DEVELOPMENT NO.:	24038084
APPLICANT:	Thomas Treloar
ADDRESS:	18 GULF PDE SOUTH BRIGHTON SA 5048
NATURE OF DEVELOPMENT:	Variation of Development Application 24036704 to add rooftop terrace to each dwelling and additional screening the rear upper-level balcony and rooftop terrace.
ZONING INFORMATION:	<p>Zones:</p> <ul style="list-style-type: none"> • General Neighbourhood <p>Overlays:</p> <ul style="list-style-type: none"> • Airport Building Heights (Regulated) • Affordable Housing • Prescribed Wells Area • Regulated and Significant Tree • Stormwater Management • Urban Tree Canopy
LODGEMENT DATE:	15 Nov 2024
RELEVANT AUTHORITY:	Assessment panel at City of Holdfast Bay
PLANNING & DESIGN CODE VERSION:	P&D Code (in effect) Version 2025.4 27/2/2025
CATEGORY OF DEVELOPMENT:	Code Assessed - Performance Assessed
NOTIFICATION:	Yes
RECOMMENDING OFFICER:	Alexander Stamatopoulos Development Officer - Planning
REFERRALS STATUTORY:	Nil

DETAILED DESCRIPTION OF PROPOSAL:

Above: Image shows the wall height being 7.14m and building height of 10m of the southern wall of Residence 2.

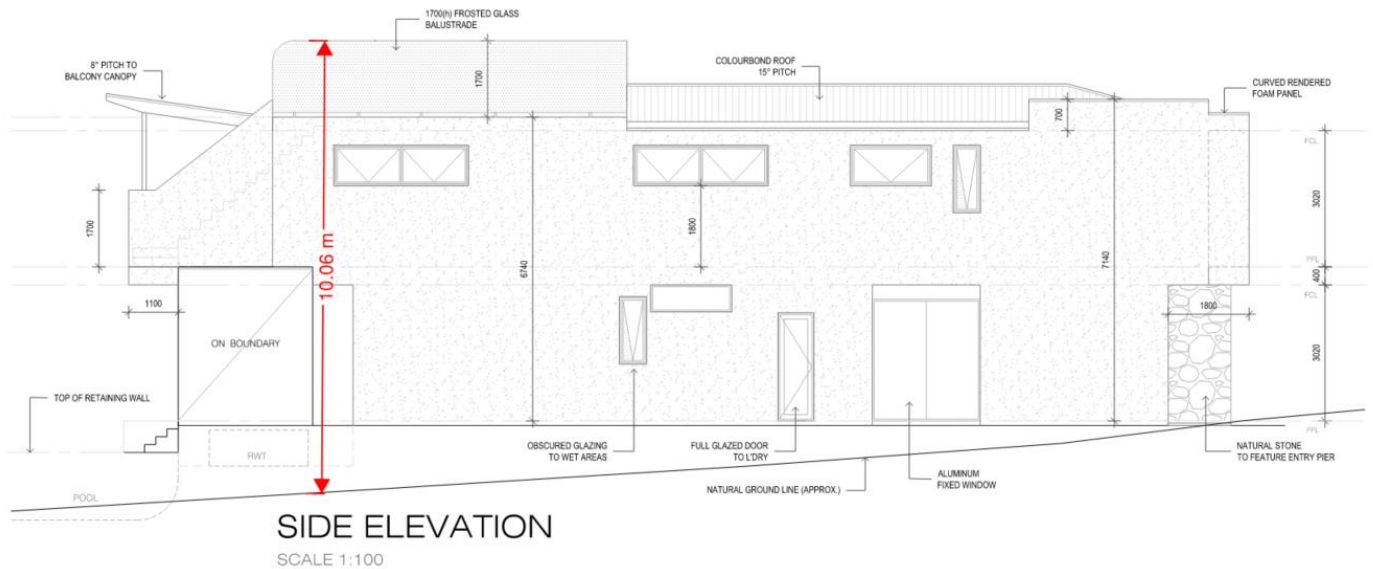
Since the terraces are not considered additional levels, the dwellings maintain the intended low-rise form, with only two building levels as specified in the policy. The side elevation plan demonstrates that the main dwelling height is wall height as measured from the top of the footing is 7.14m. While the building height from the existing natural ground level is 10m to the top of the glass balustrading.

The 140mm exceedance of the wall height and 1m of the building height is not considered to be detrimental in achieving the PO 4.1. The highest point of the dwellings are to the top of the balustrading which contains a modest scale that does not dominate the built form and maintains visual harmony with the surrounding dwellings. Having the deck recessed in from the level below, in particular 9m from the rear boundary, provides visual relief. This approach ensures that the overall appearance of the development remains in keeping with the scale of the existing streetscape.

9am Shadows Below (left compliant setback dwellings, right proposed dwellings)

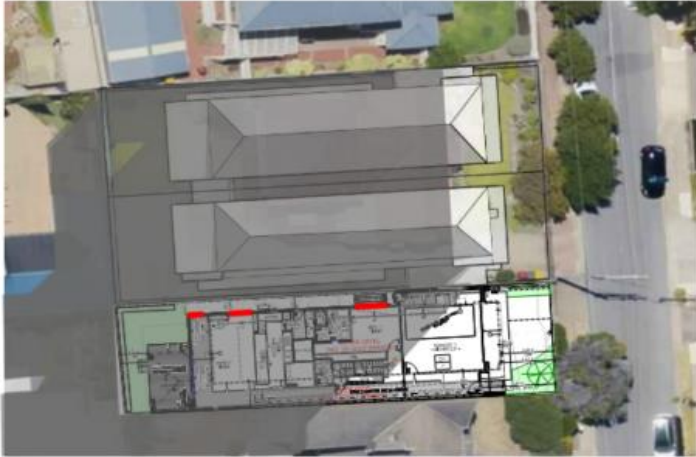
In analysing the overshadowing diagrams provided for the proposed development at 18 Gulf Parade, South Brighton, both the proposed and compliant shadowing plans show relatively similar impacts throughout the day.

- The shadows cast at this time extend significantly towards the neighbouring southern property, particularly affecting the area where the north-facing habitable room windows are located.
- The proposed shadowing and compliant shadowing diagrams show almost identical shadow lengths and coverage over these windows. This suggests that the difference between the proposed setbacks and a compliant 2.9m setback has minimal impact in the early morning.

- At noon, the sun is higher in the sky, resulting in shorter shadows. Both the proposed and compliant diagrams display shadows primarily affecting the lower levels of the southern neighbouring dwelling.
- Once again, the comparison reveals very little difference between the proposed and compliant shadows.

- In the afternoon, the shadows extend further east, with some lengthening along the southern boundary.
- The difference between the proposed and compliant shadowing is minimal. Both diagrams show that while some portions of the neighbouring property experience overshadowing, the habitable room windows will not contain access to some natural light during this time.

The overshadowing diagrams demonstrate that even a compliant two-storey detached dwelling, with the required 2.9m upper-level setback, would result in overshadowing of the southern adjoining dwelling. The proposed design, with reduced setbacks, shows a negligible difference in the extent of overshadowing when compared to the compliant scenario. At all critical times of the day (9 AM, 12 PM, and 3 PM), the shadows cast by the proposed development do not result in substantially more overshadowing than what would occur with a compliant two-storey dwelling.

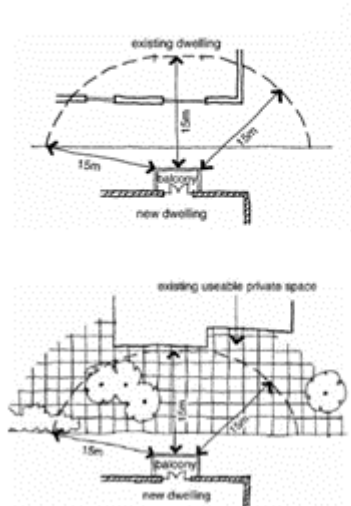
The applicant has provided line of sight diagrams from the balcony and rooftop decks that show the extent of views consistent with the definition of direct overlooking. The dwelling located directly to the west of the subject land, 180 Esplanade, contains its useable outdoor areas to the front where a swimming pool and front verandah/balconies are located. The rear of the property contains a garage and a driveway which functions more as an access area for vehicles as opposed to an area of private amenity. The rear upper-level windows of 180 Esplanade contain obscured glazing to appropriate heights therefore no overlooking will occur into habitable room windows.

The proposed privacy balustrades to the balconies and roof top terraces are suitable to mitigate overlooking into 179 and 180 Esplanade.
